Choosing 25G CRU BW and CDR BW Wisely

Nov 15, 2009

**Ali Ghiasi, Afshin Momtaz, Magesh Valliappan
Broadcom Corporation
aghiasi@broadcom.com**

Background Statement

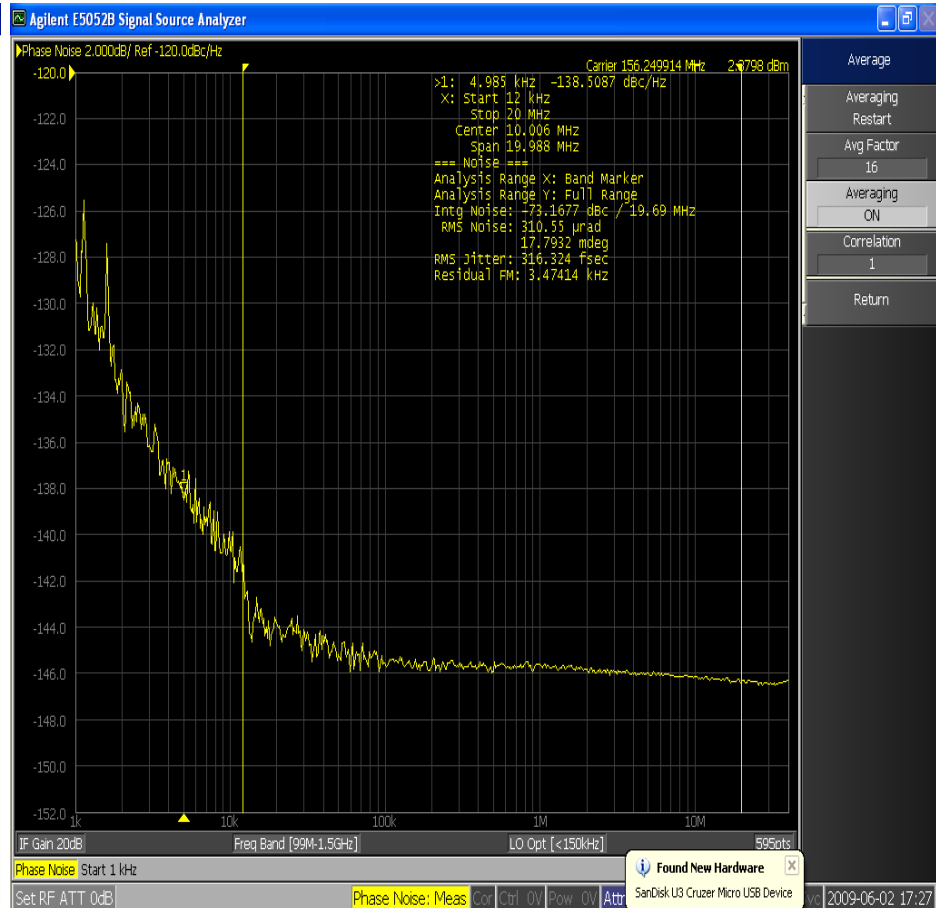
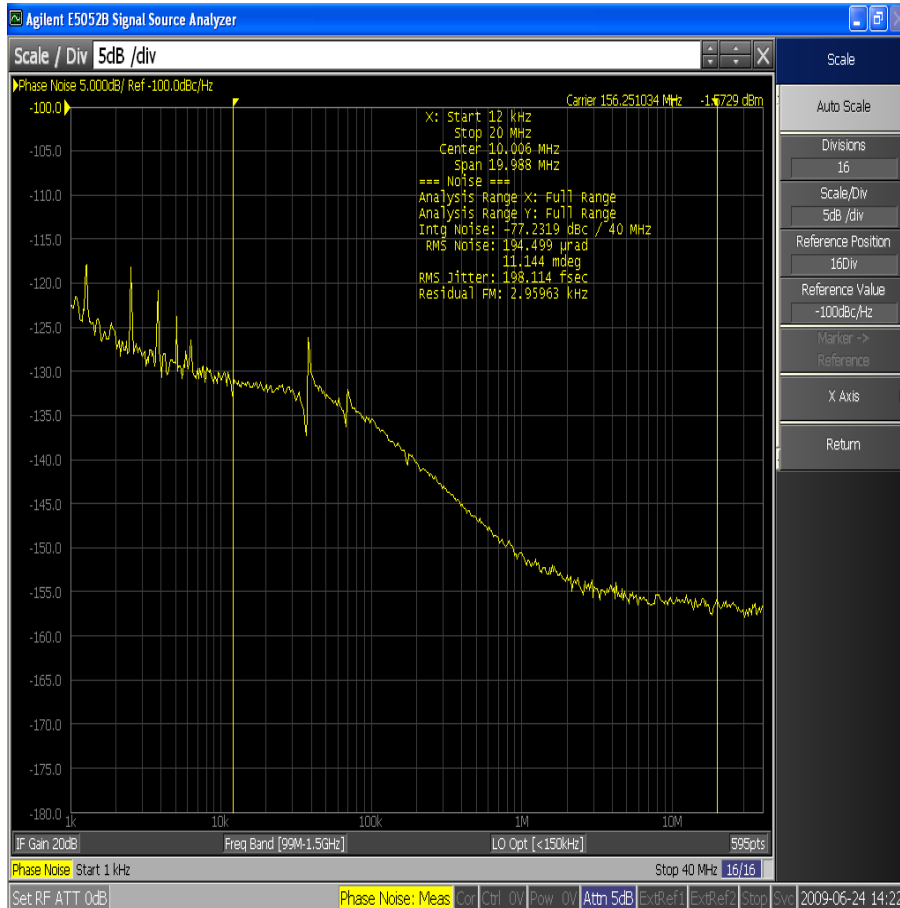
- **88.8.5.3 Reference Receiver, defines CRU used for TDP measurement has 10 MHz BW**
- **88.8.8 Transmitter optical waveform, is defined with CRU with 10 MHz corner frequency**
- **88.8.10 Stress receiver sensitivity, table 88-13 had effective corner frequency of 4 MHz CDR**
- **The recommendation given in ghiasi_02_0909 was to reduce the CRU BW from 10 MHz to 7 MHz and use the same corner frequency for jitter tolerance**
- **The decision in Chicago was to correct the jitter tolerance table 88-13 corner frequency from 4 MHz to 10 MHz, making the specification consistent but there were no consensus on the other part of the recommendation to make the CRU and CDR BW both 7 MHz.**

SerDes Transmitter Relative Jitter

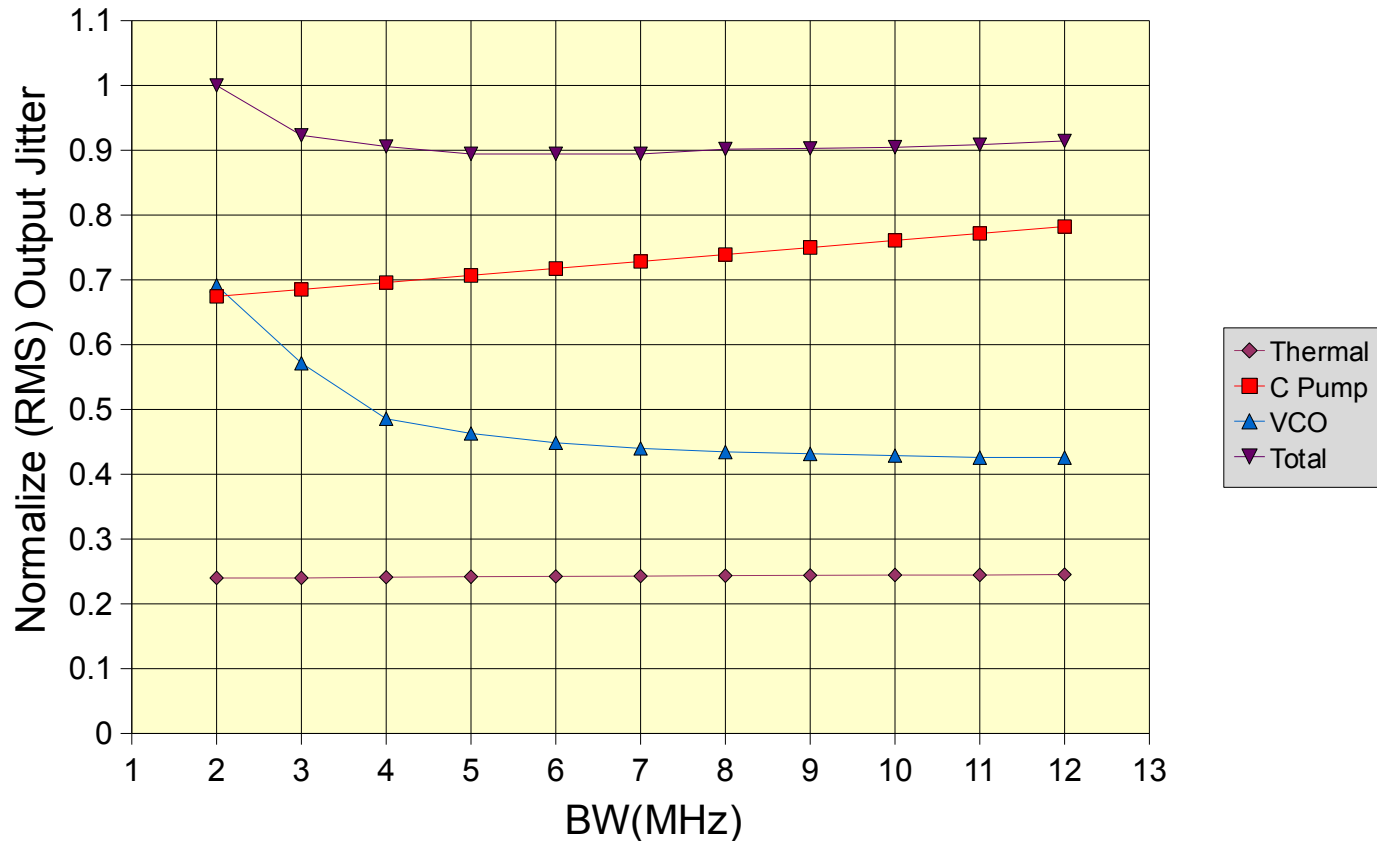
- Thermal, charge pump, VCO, and total relative output jitter as function of BW
 - BW of 5-7 MHz gives best total output jitter and there is no benefit having CRU BW > 7 MHz

100GBase-LR4/ER4 Current Implementation

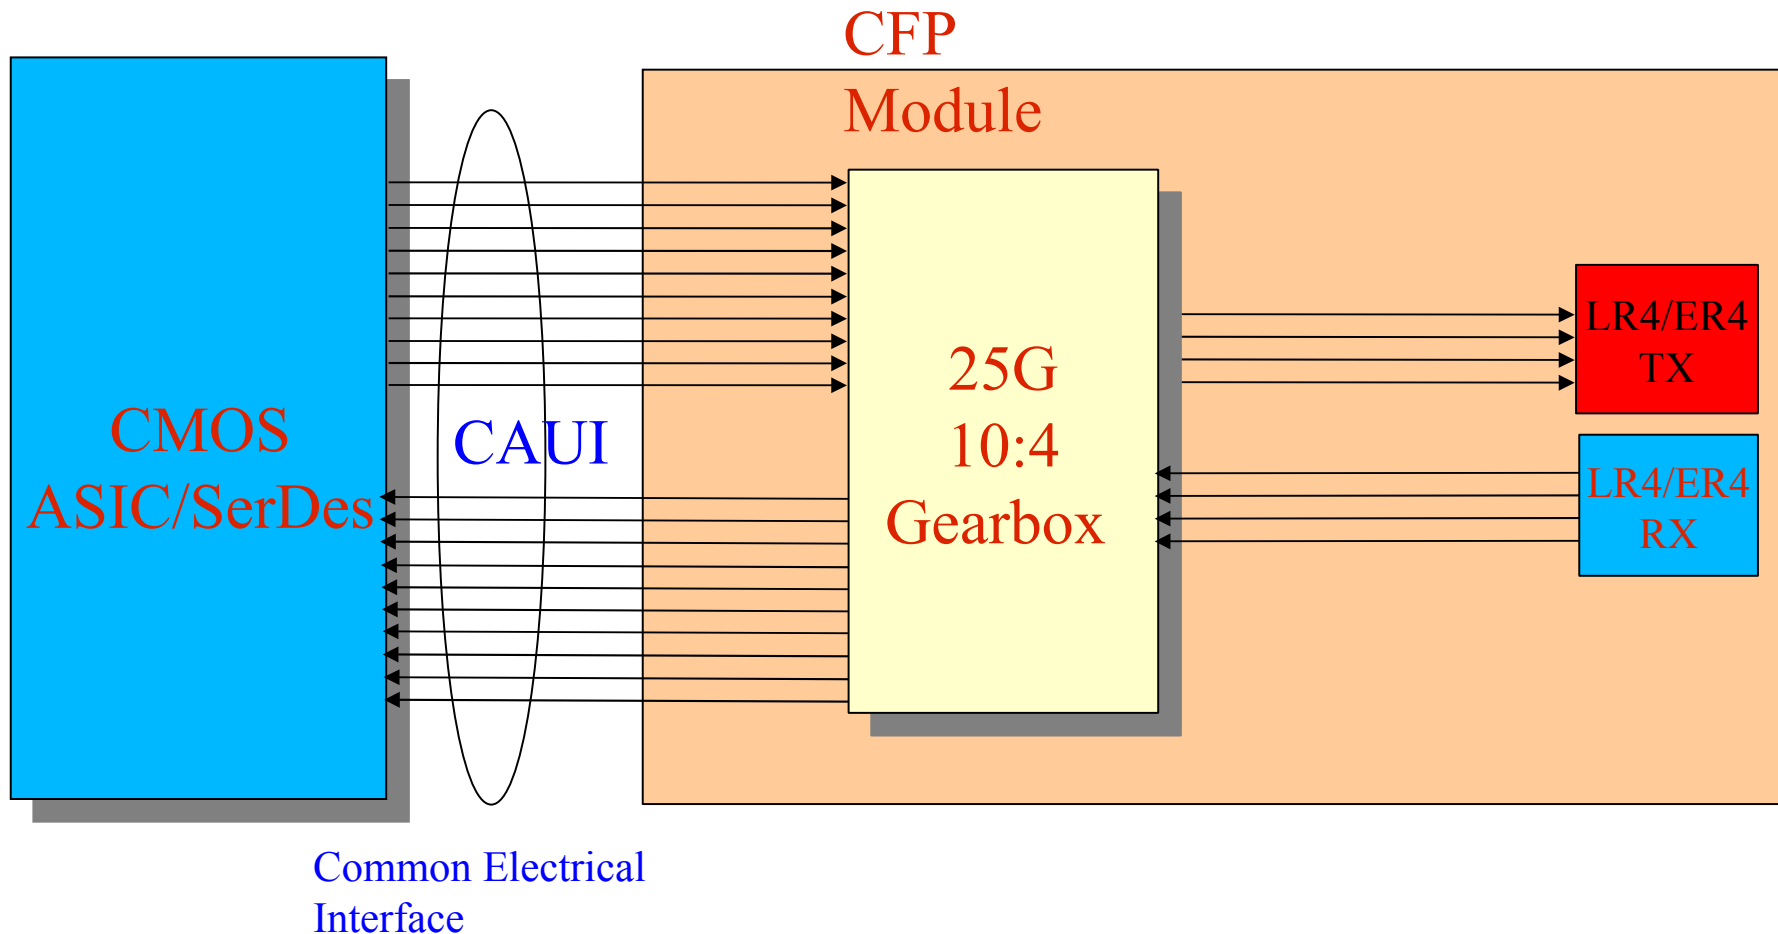
- Module interface based on CAUI
- The jitter tolerance defined for LR4/ER4 will remain for ever!

Next Generation 100GBASE-LR4/ER4

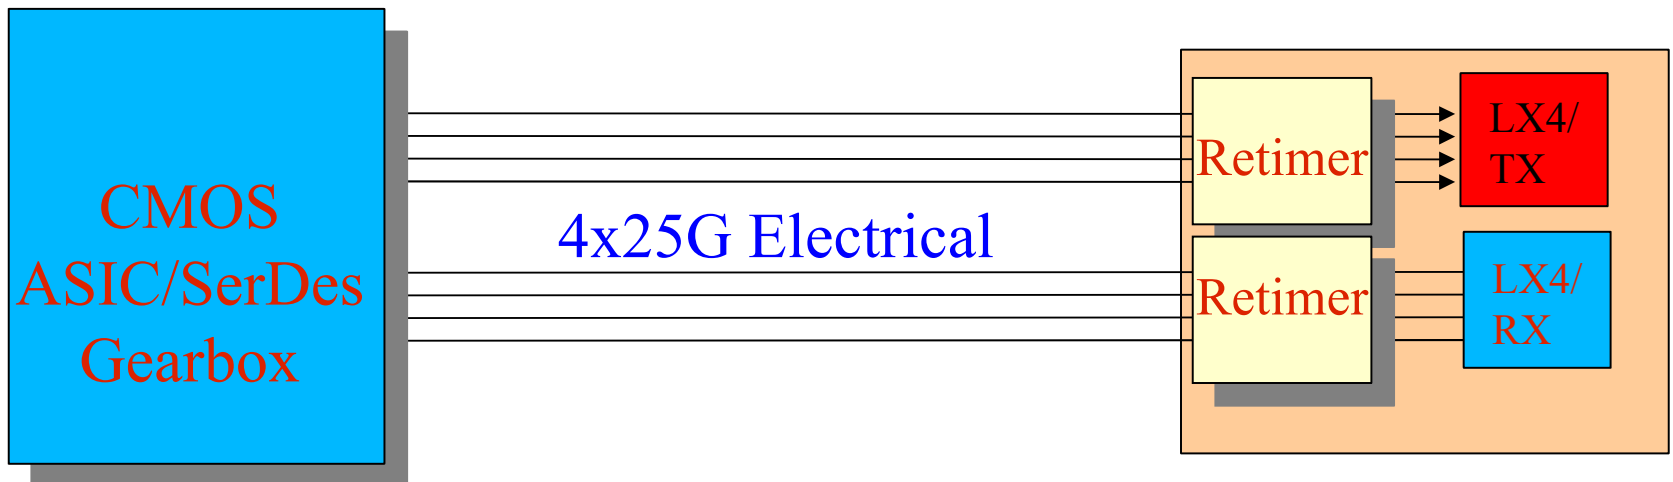
- Next ASIC/Serdes will integrate the 4x25G gearbox
- Interface operating at 25.7 Gbd will require some DFE
- The retimer in the module will pass through SJ stress
- The 4x25G host receiver must absorb the SJ!

10 GbE SJ Mask and Proposed 100 GbE Mask

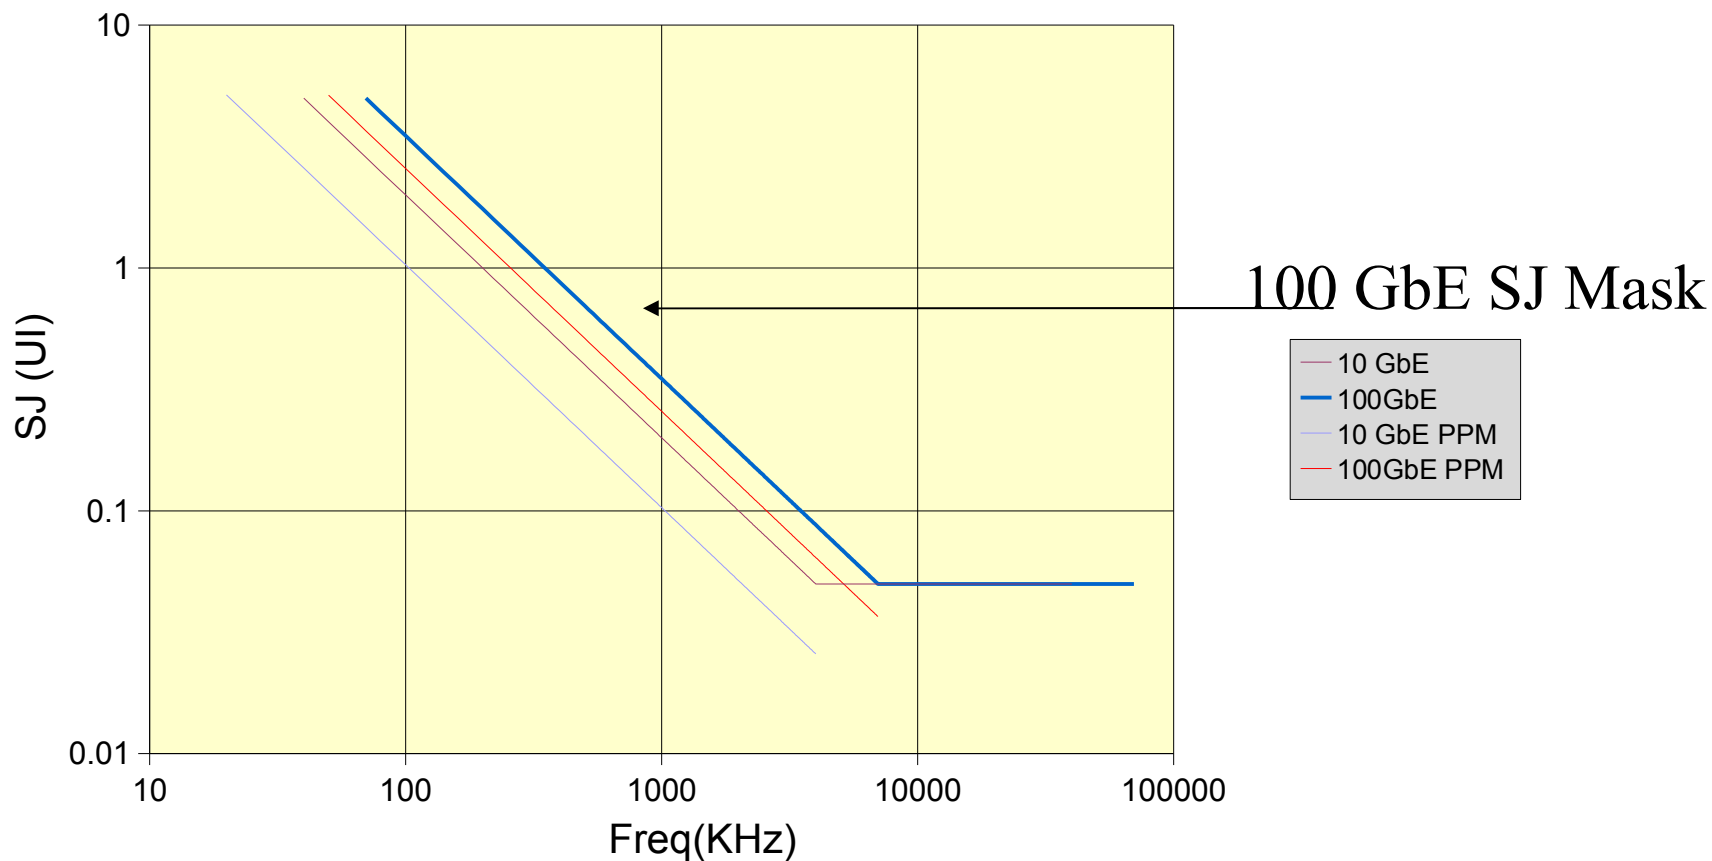
- 100 GbE mask with proposed compromised 7 GHz BW
